**Ver5.0 (The method is different from Ver2.0)**

This is a method to update the Futaba R334SBS / R334SBS-E receiver from the T7PX/T7XC.

## R334SBS/R334SBS-E SOFTWARE UPDATE CHANGES

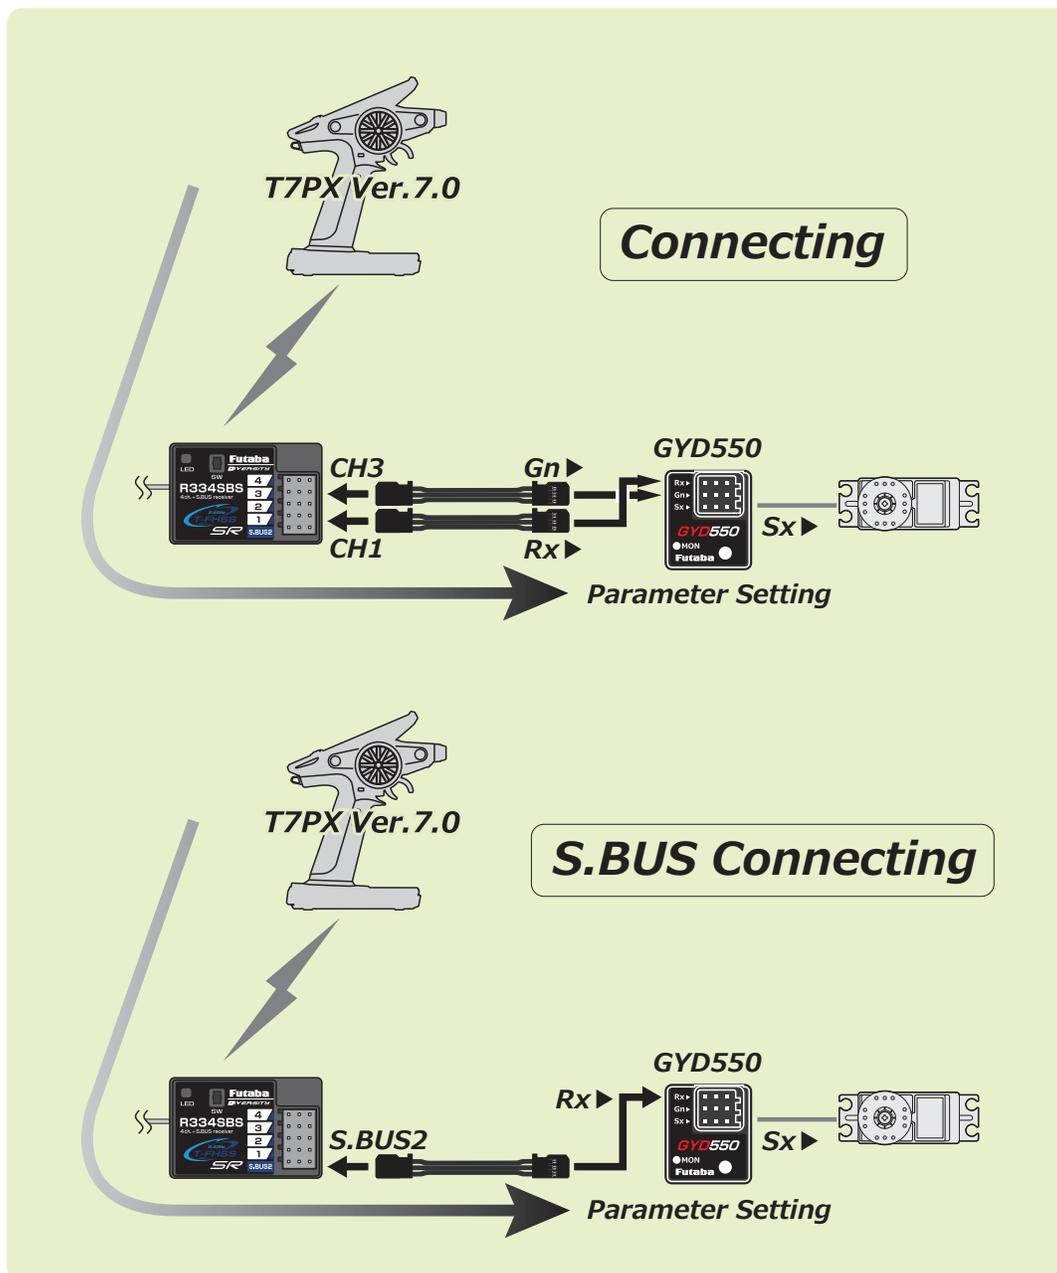
Version: 5.0

Improved the radio communication quality of R334SB/ R334SBS-E.

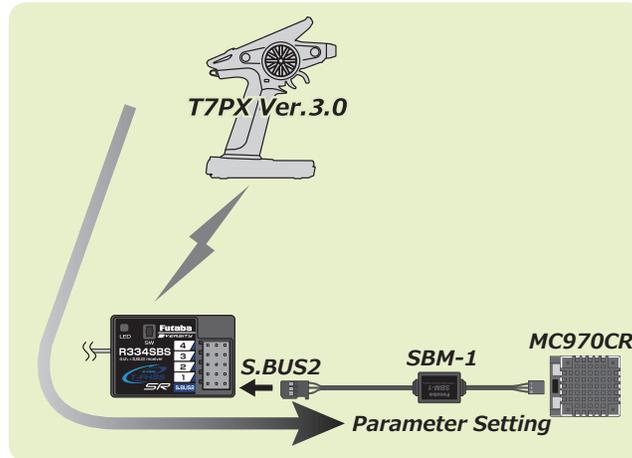
### 1. Compatible with Wireless MC970CR parameters setting function

The operating parameters of the Futaba MC970CR connected to receiver can be set and changed from the transmitter wirelessly.

\*Transmitter (T7PX/T7XC) also needs to be updated to version 3.0.
